RE: Proposed Nagog Pond Water Treatment Plant, Acton, Massachusetts
Notice of Intent – Supplemental Submittal
MassDEP File Number: CE 085-1188

NAGOG POND WATER TREATMENT PLANT

RE: Proposed Nagog Pond Water Treatment Plant
Response to Comments - NOI Hearing (December 2, 2015)

FOR PERMITTING
Sheet No.
C-9

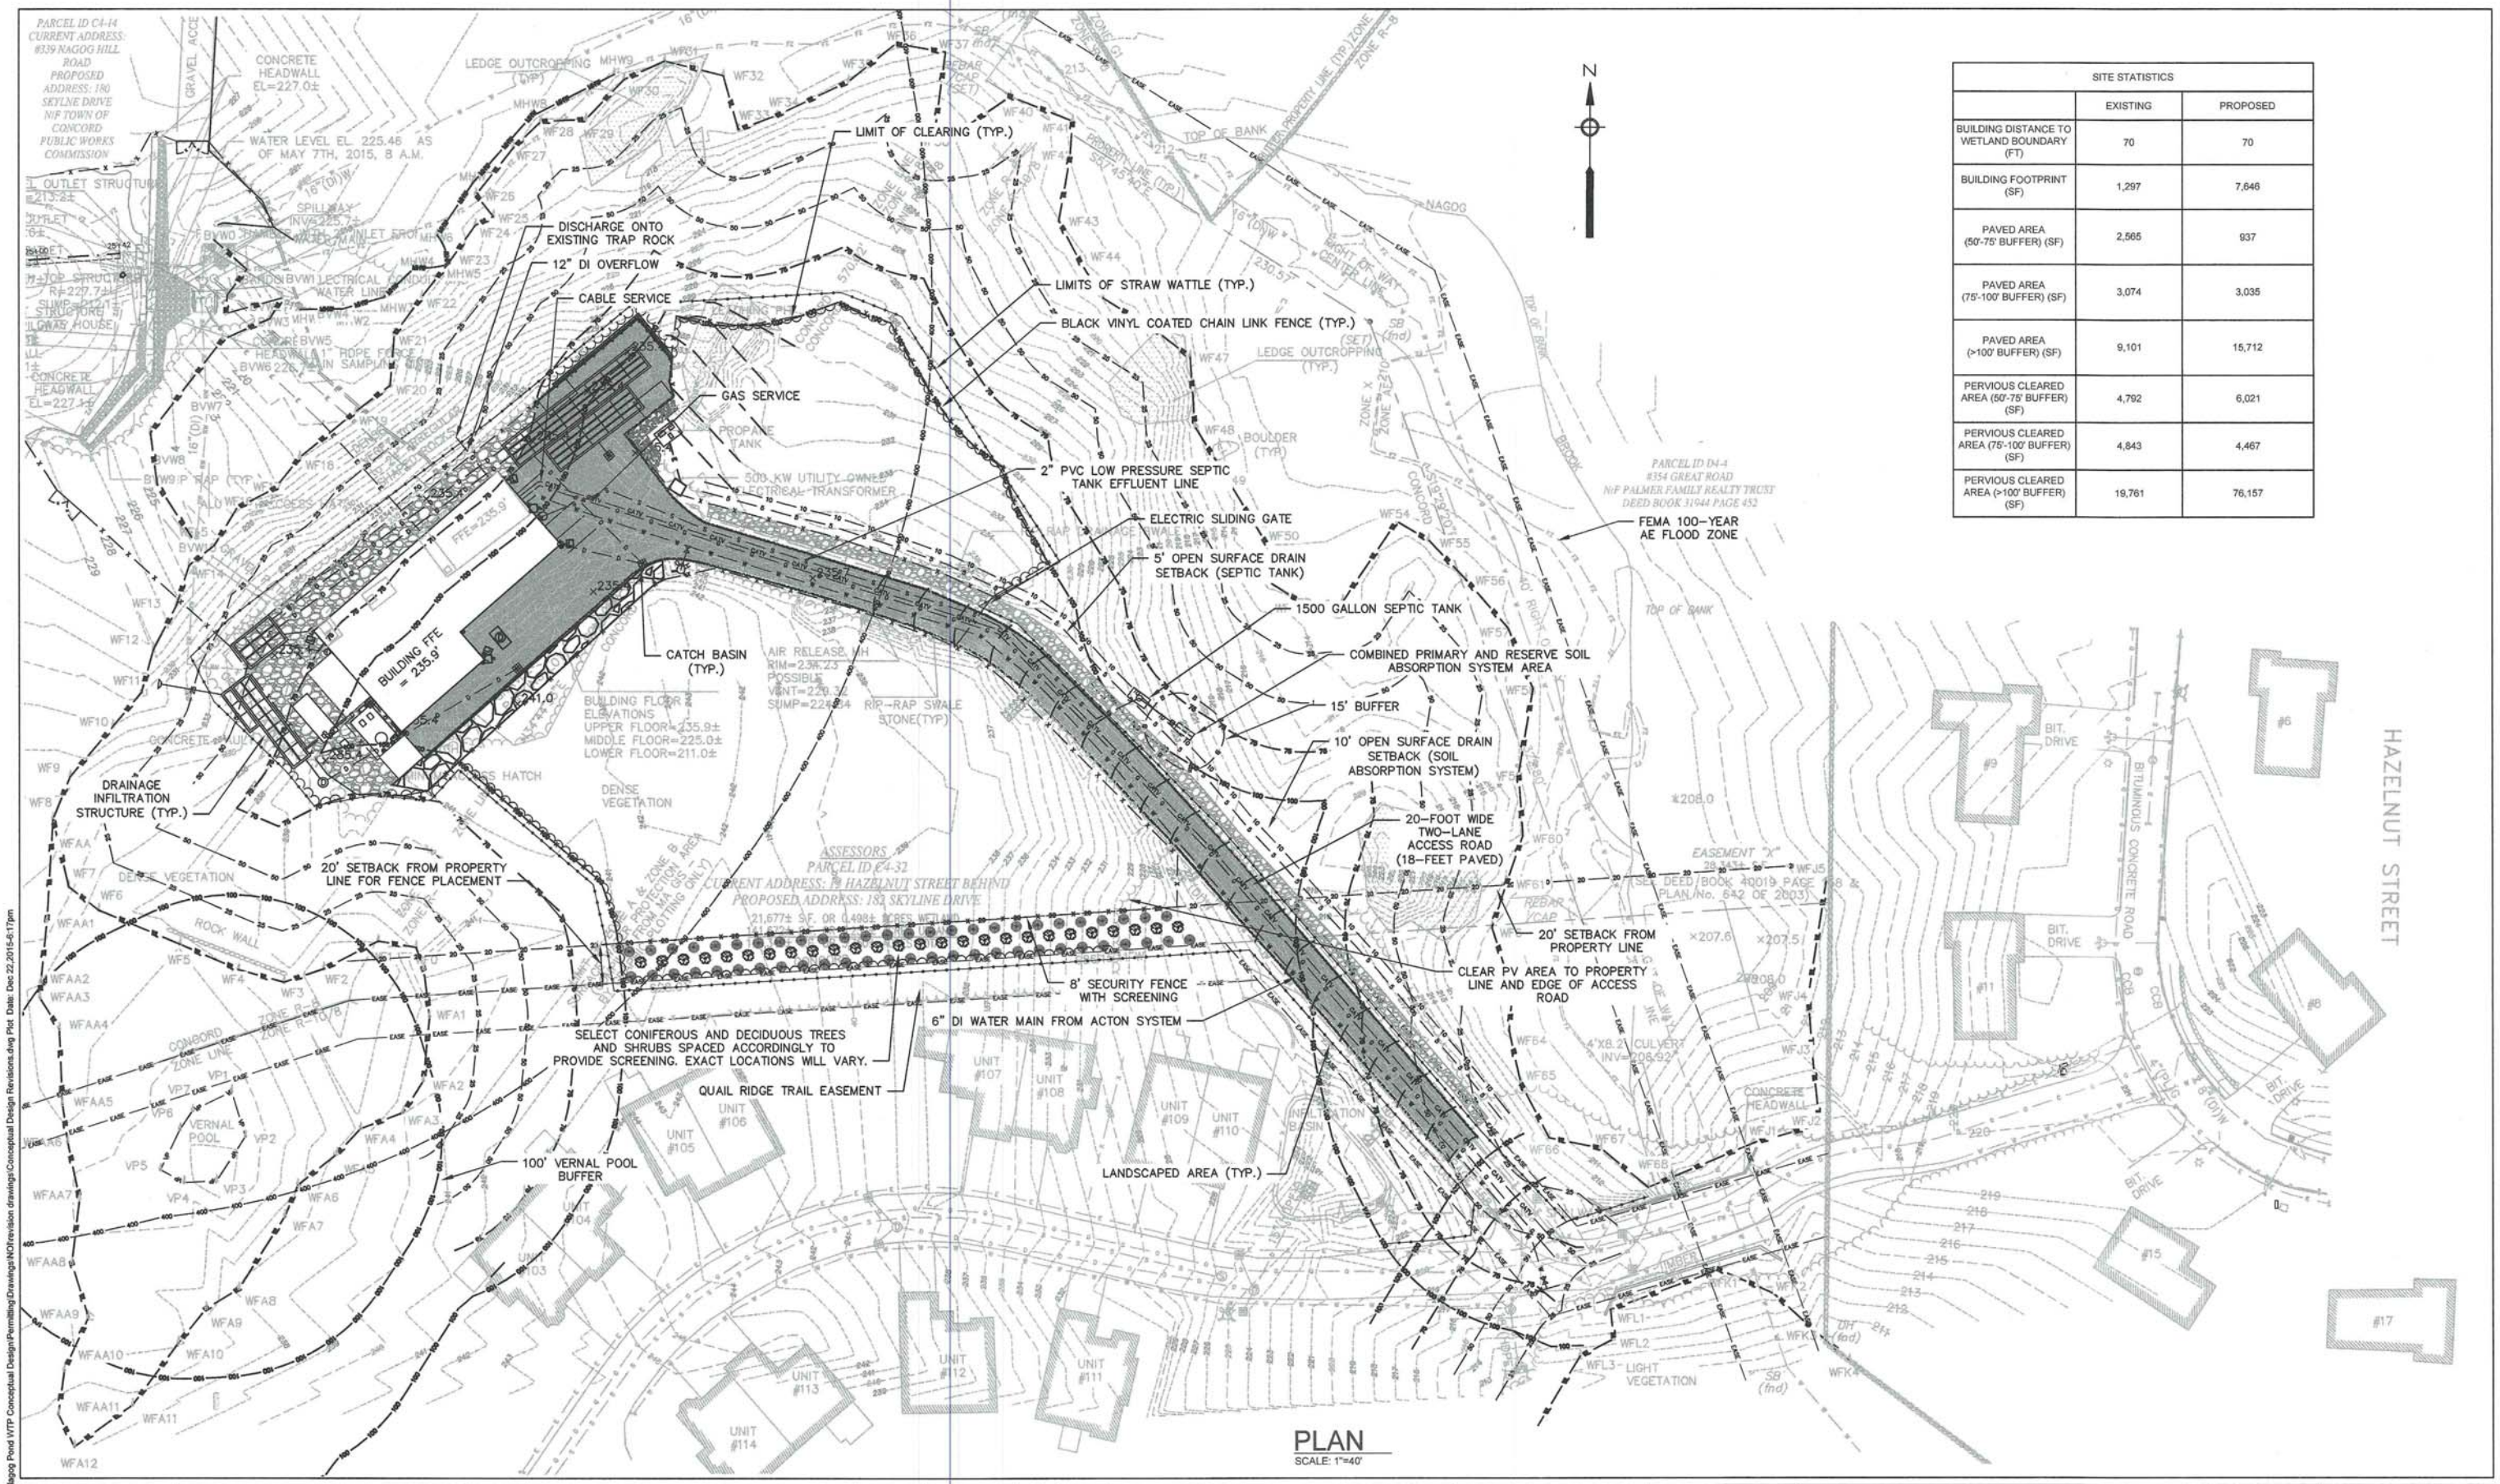
2. According to the "Environmental Partners Technical Memorandum," the project's engineering firm, submitted to the Town of Acton, the existing structure of 1,291 square feet will be increased to a net floor space of 9,338 square feet. The total lot size for this proposed structure will increase from 17,374 square feet, to 47,526 square feet.

As requested by the Conservation Commission, the revised plan Sheet C-9 includes a table of existing and proposed site features including clearing, pervious, and impervious areas. There are no proposed changes being made to the stormwater and drainage systems previously submitted. Based on the limited site changes proposed, it is anticipated that there will be negligible differences in stormwater management. As indicated by the previous stormwater analysis, it is expected that the peak stormwater discharge rates will be lower compared with existing conditions. An updated Stormwater Report has not been completed, but will be prepared and submitted separately.

SITE STATISTICS		
	EXISTING	PROPOSED
BUILDING DISTANCE TO WETLAND BOUNDARY (FT)	70	70
BUILDING FOOTPRINT (SF)	1,297	7,646
PAVED AREA (50'-75' BUFFER) (SF)	2,565	937
PAVED AREA (75'-100' BUFFER) (SF)	3,074	3,035
PAVED AREA (>100' BUFFER) (SF)	9,101	15,712
PERVIOUS CLEARED AREA (50'-75' BUFFER) (SF)	4,792	6,021
PERVIOUS CLEARED AREA (75'-100' BUFFER) (SF)	4,843	4,467
PERVIOUS CLEARED AREA (>100' BUFFER) (SF)	19,761	76,157

Please refer to the revised Sheet C-9 for an update on the site and facility area statistics.

FOR PERMITTING
Sheet No.
C-9S

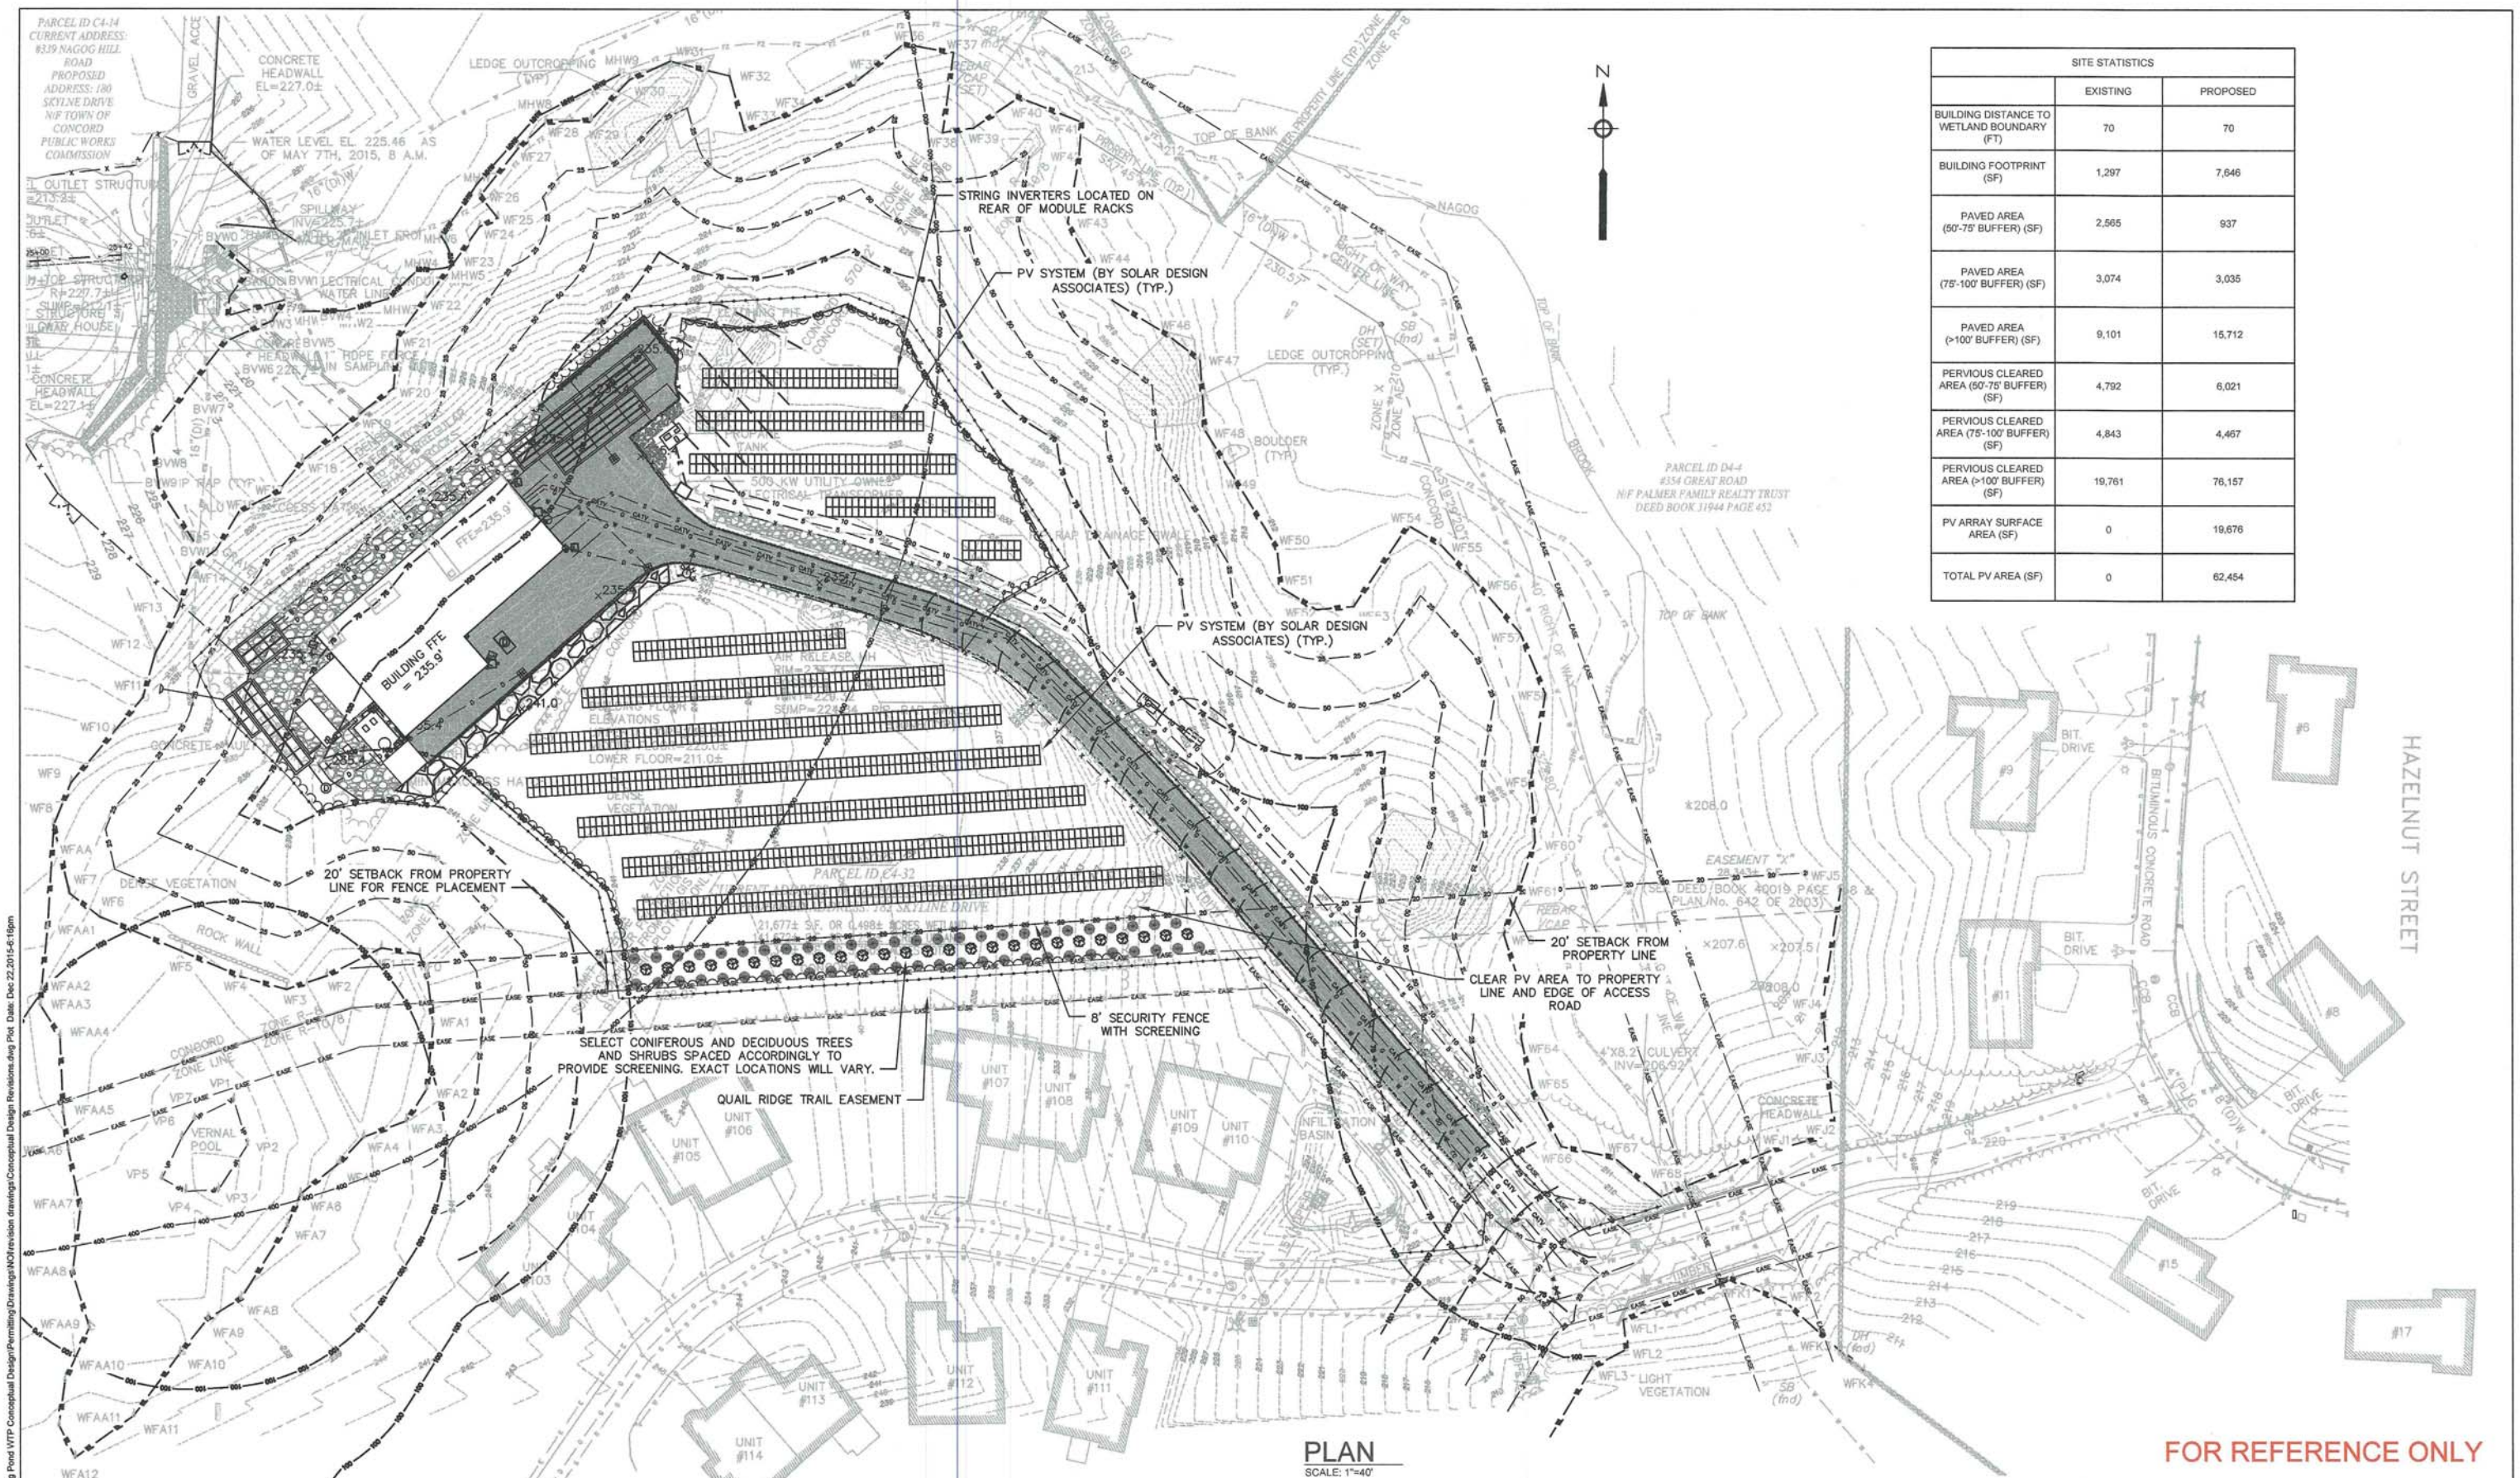
4. Many of the solar panels (more than 50% in my layman's estimation) are proposed to be located within the 100 foot buffer zone.

3. Additionally, according to the Memorandum, "the solar field will include an area of approximately 68,743 square feet for the installation of 17,768 square feet of photovoltaic arrays (PV)."

A new site plan has been prepared and submitted to the Conservation Commission. There are no PV facilities or activities (including site clearing) being proposed within 100 feet of a wetland boundary or a vernal pool. Therefore, the PV component of this project is outside the jurisdiction of the Conservation Commission and no approval from the Conservation Commission for the proposed PV facilities associated with this project is being sought.

Please refer to Sheet C-9S for an update of the PV area and PV panel surface area.
